**Docket:** NRC-2015-0070

Regulatory Improvements for Power Reactors Transitioning to Decommissioning

Regulatory Improvements for Power Reactors Transitioning to Decommissioning; Request for Comment on Draft Regulatory Basis

Comments re: NRC -2015-0070: PROPOSED *REGULATORY IMPROVEMENTS*  
FOR DECOMMISSIONING POWER REACTORS.

### Fire danger in nuclear pools underestimated, scientists say

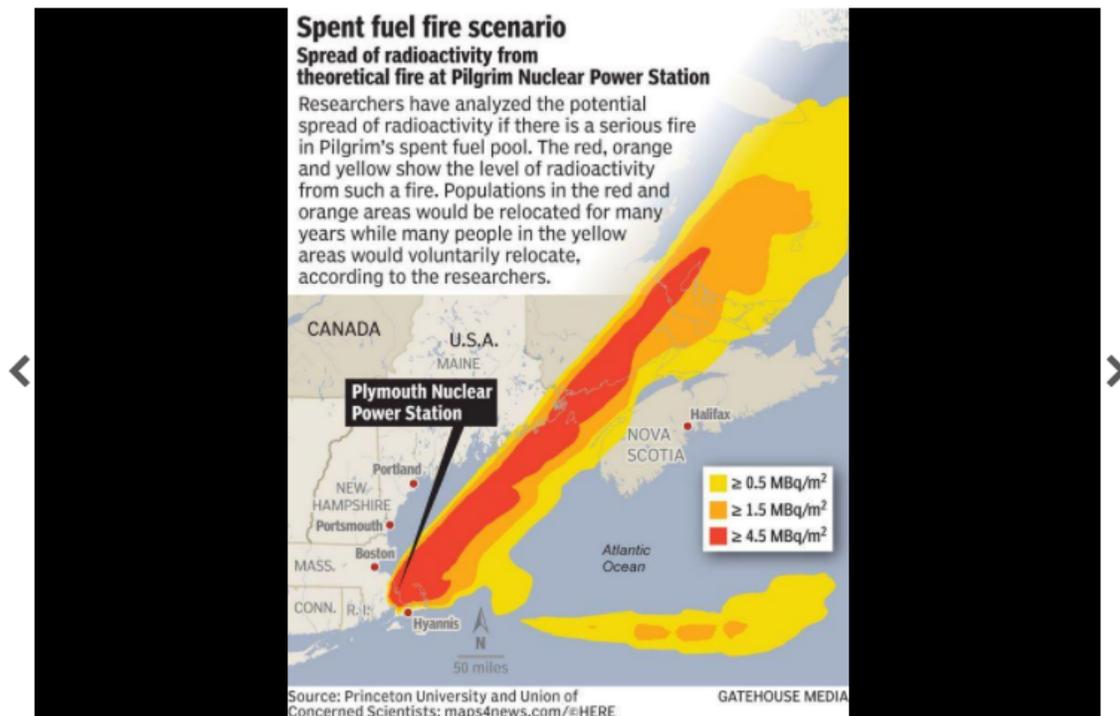
A fire in any of the 90 U.S. nuclear reactors' densely-packed spent fuel pools could release considerably more radiation than the 2011 reactor meltdowns at Fukushima Daiichi, according to recent work by Edwin Lyman (Union of Concerned Scientists) and Princeton University researchers Michael Schoeppner and Frank von Hippel.

A major fire could force the evacuation of millions dwarfing the accident at Fukushima and resulting in trillion dollar consequences.

The researchers assumed a release of 1600 petabecquerels of Cs-137, the average amount that the NRC estimates would be released from a fire at a densely-packed pool. This is approximately 100 times the amount of Cs-137 spewed at Fukushima.

Here's an illustration, as reported by my local paper, the Cape Cod Times, assuming wind from the southwest:
